City of Portland, Maine - Building or Use Permit Application 389 Congress Street, 04101, Tel: (207) 874-8703, FAX: 874-8716 Permit No: Location of Construction: Owner: Phone: 774-2778 Owner Address: Lessee/Buyer's Name: Phone: BusinessName: Permit Issued: Phone: Contractor Name: Address: SAA SEP 2 2 1998 COST OF WORK: PERMIT FEE: Past Use: Proposed Use: 6.000.00 50.00 **FIRE DEPT.** □ Approved INSPECTION: 1-fam Same Use Group: Type: ☐ Denied CBL: Zone: 177-E-008 Signature: Signature: Zoning Approval: Proposed Project Description: PEDESTRIAN ACTIVITIES DISTRICT (P.A.D.) Action: Approved Special Zone or Reviews: Approved with Conditions: int Reno to Attic Space ☐ Shoreland Denied □ Wetland ☐ Flood Zone ☐ Subdivision Date: Signature: ☐ Site Plan maj ☐minor ☐mm ☐ Permit Taken By: Date Applied For: MG € 11.00 p 09 Sept 98 **Zoning Appeal** □ Variance This permit application does not preclude the Applicant(s) from meeting applicable State and Federal rules. ☐ Miscellaneous Building permits do not include plumbing, septic or electrical work. ☐ Conditional Use Building permits are void if work is not started within six (6) months of the date of issuance. False informa-□ Interpretation ☐ Ap

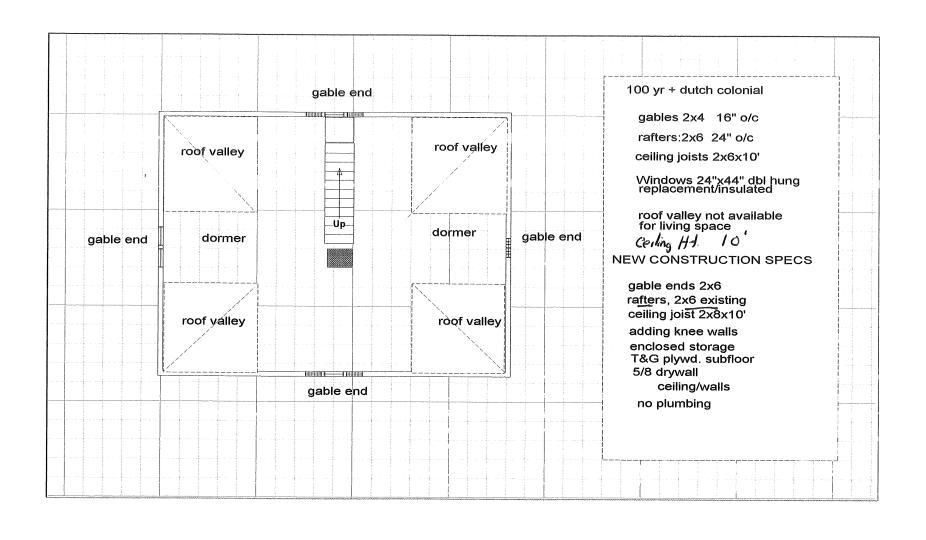
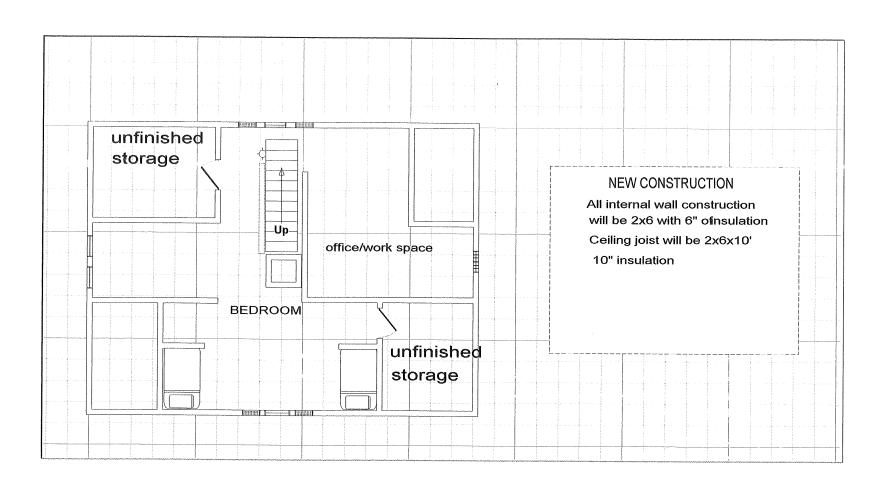
1.	Sound transmission control in residential building shall be done in accordance with Chapter 12 section 121±.0 of the city's
_	building code.
(Guardrails & Handrails: A guardrail system is a system of building components located near the open sides of elevated
	walking surfaces for the purpose of minimizing the possibility of an accidental fall from the walking surface to the lower
	level. Minimum height all Use Groups 42", except Use Group R which is 36". In occupancies in Use Group A, B, H-4, I-1, I-2 M and R and public garages and open parking structures, open guards shall have balusters or be of solid material such
	that a sphere with a diameter of 4" cannot pass through any opening. Guards shall not have an ornamental pattern that
	would provide a ladder effect. (Handrails shall be a minimum of 34" but not more than 38". Use Group R-3 shall not be
	less than 30", but not more than 38".) Handrail grip size shall have a circular cross section with an outside diameter of at

least 1 1/4" and not greater than 2". (Sections 1021 & 1022.0)
	Headroom in habitable space is a minimum of 7'6". (Section 1204.0)
), •	Stair construction in Use Group R-3 & R-4 is a minimum of 10" tread and 7 3/4" maximum rise. All other Use group
	minimum 11" tread. 7" maximum rise.(Section 1014.0)
	The minimum headroom in all parts of a stairway shall not be less than 80 inches. (6'8") 1014.4
÷ 12. 1	Every sleeping room below the fourth story in buildings of use Groups R and I-1 shall have at least one operable window or
